ARCHITECTURAL REVIEW BOARD MEETING
CITY HALL, 385 SOUTH GOLIAD, ROCKWALL, TEXAS
JUNE 14, 2022 IN THE CITY COUNCIL CONFERENCE ROOM AT 5:00 PM

PLANNING AND ZONING COMMISSION CASE MEMO

TO: Planning and Zoning Commission
DATE: June 14, 2022
APPLICANT: David Gregory; *DCG Engineering, Inc.*
CASE NUMBER: SP2022-025; *Site Plan for Einstein Bros Bagel*

SP2022-026: Site Plan for Qdoba

01 Elevations (West)
 SCALE: 1/4" = 1'-0"

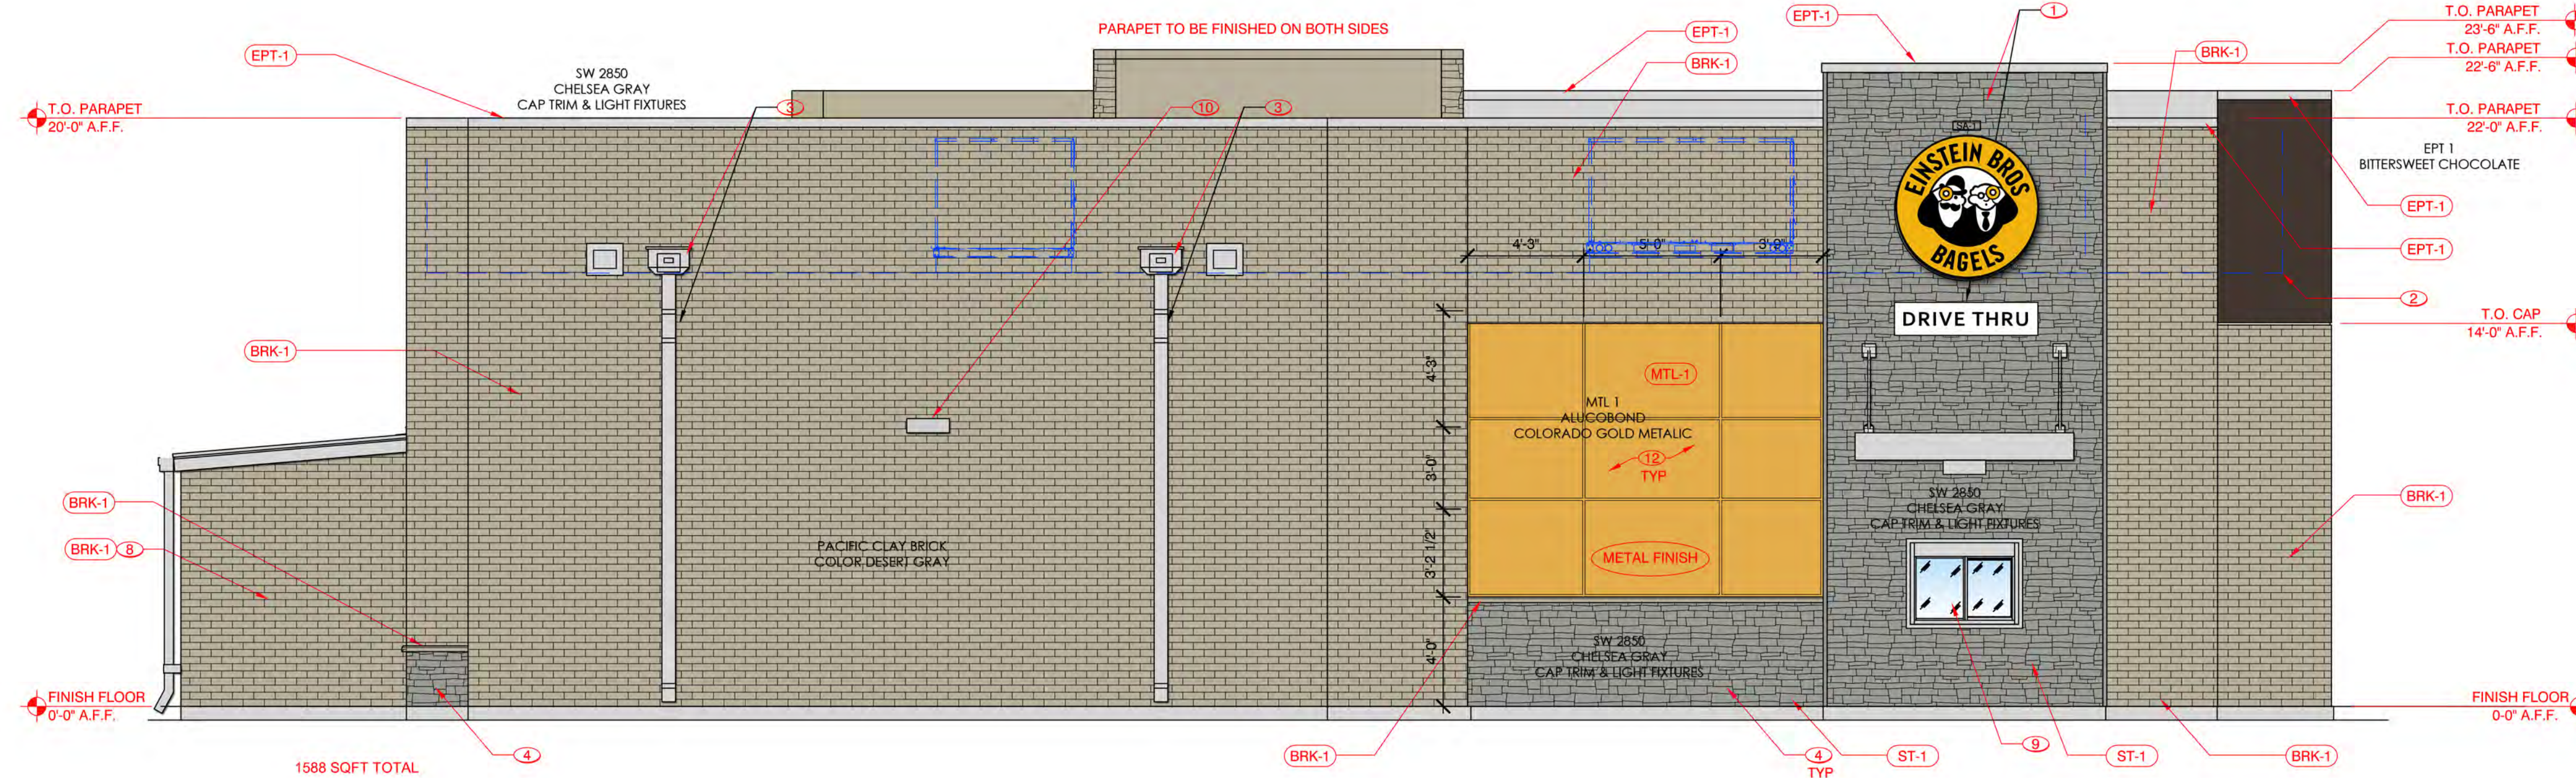
The Architectural Review Board (ARB) reviewed the building elevations provided by the applicant on May 31, 2022, and made the following recommendations: [1] provide stone up the tower elements, [2] break-up the drive-through façade with a bump

out, [3] clad the equipment screening on the rear of the building in brick/stone, and [4] provide a similar color palette and materials as the Dutch Bros Coffee. As an example of consistent design, the ARB directed the applicant to review the buildings at the southwest corner of N. Goliad Street and N. Lakeshore Drive. Before action is taken on the building elevations, the ARB will review the applicant's revised building elevations and provide a recommendation to the Planning and Zoning Commission at the June 16, 2022 meeting.
